## Cork Line Level Crossings Road Safety Audit Stage 1

Iarnród Éireann

Project No: 32111000  
Document Title: Cork Line Level Crossings – Road Safety Audit Stage 1  
Document No.: 32111000/CLC/RSA01, Revision 1  
Revision: P02  
Date: September 2019  
Client Name: Iarnród Éireann

Figure 2-1 Proposed Footpath

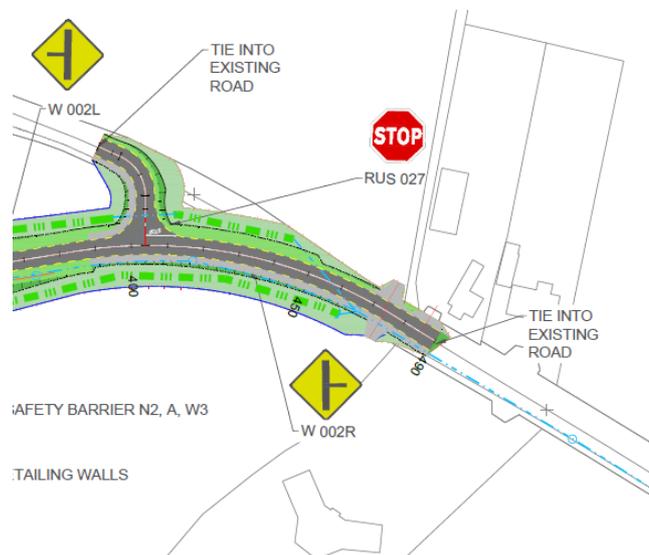
Where the new road alignment ties in with the existing road to the eastern extent of the scheme, there is a proposed footpath. This ties in with the existing footpath on southern side of the carriageway, which is currently street lit.

The proposed footpath terminates on southern side of the carriageway and continues a short distance down a new side road to the northern side of the carriageway. Pedestrians could find themselves crossing on a bend, which could result in them being in conflict with vehicles if there is insufficient forward visibility.

The design team need to ensure there is adequate visibility to safely allow pedestrians cross the road. The design team should ensure that public lighting is provided along the footpath.

Figure 2-3 Tie in between existing and new road alignment

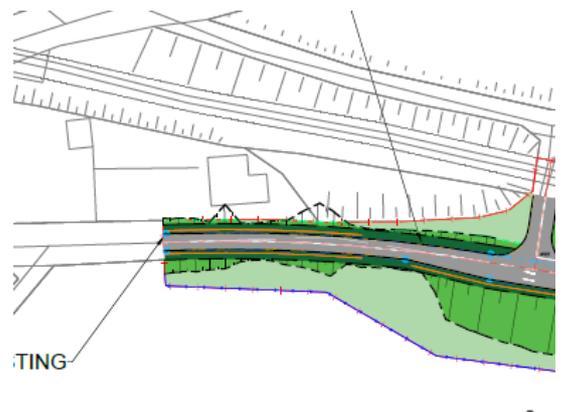
There is an existing public house with parking bays that front the highway as well as a car park, the Audit Team are concerned that with the removal of the on-street parking and introduction of the verge that drivers will still park on the road, reducing the width of the carriageway, this could result in side swipe or head on collisions.

The Design Team shall ensure that the proposed alignment ties in with existing and that the access to the car park is retained and consider the introduction of parking restrictions.

Figure 2-5 Cul De Sac Warning Signs

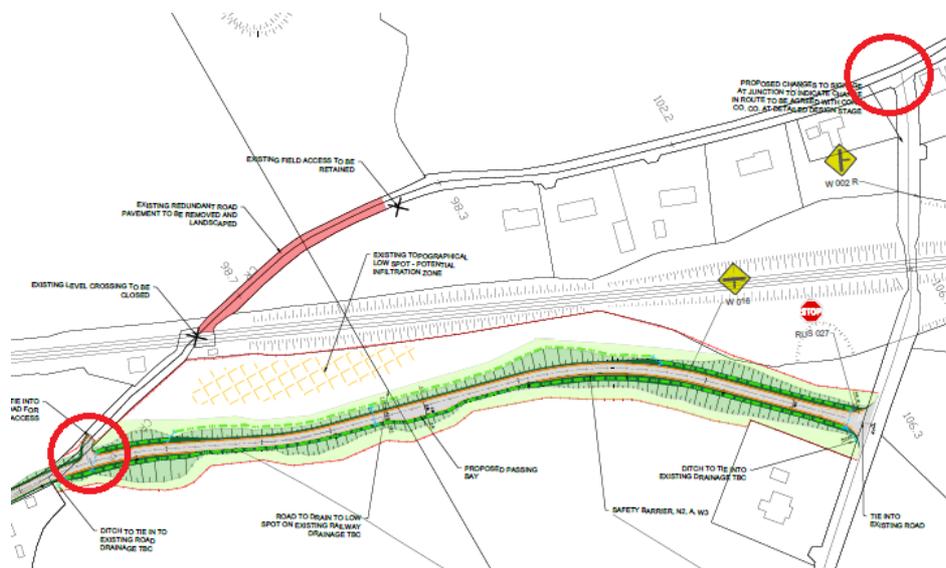
The Audit Team is concerned that motorists unfamiliar with the new layout, will be unaware of the closure of the level crossing with no turning head provided to allow vehicles to turn and exit. The lack of a turning head may result in vehicles having to reverse over a long distance leading to a loss of control type collisions.

The design team shall provide a turning head at the end of these proposed cul de sacs. A F 350: Cul-de-sac sign shall be provided in accordance with the Traffic signs Manual at the entrance to each local road.

2.3.3	Yes	Yes		
2.3.4	Yes	Yes		
2.4.1	Yes	Yes		
2.4.2	Yes	No	Ch 0+075 will be a gated private access, so no signage required. North of the closed level crossing, a F 350: Cul-de-sac sign shall be provided at L5534-0 / L5535-0 T-junction. It is also proposed to recommend to Cork Co. Co. to change priority of this junction. There is existing property entrance near end of cul-de-sac with gate set back from road which would allow for vehicle turning. Dedicated turning head will not be included to avoid increased risk of illegal dumping.	Yes
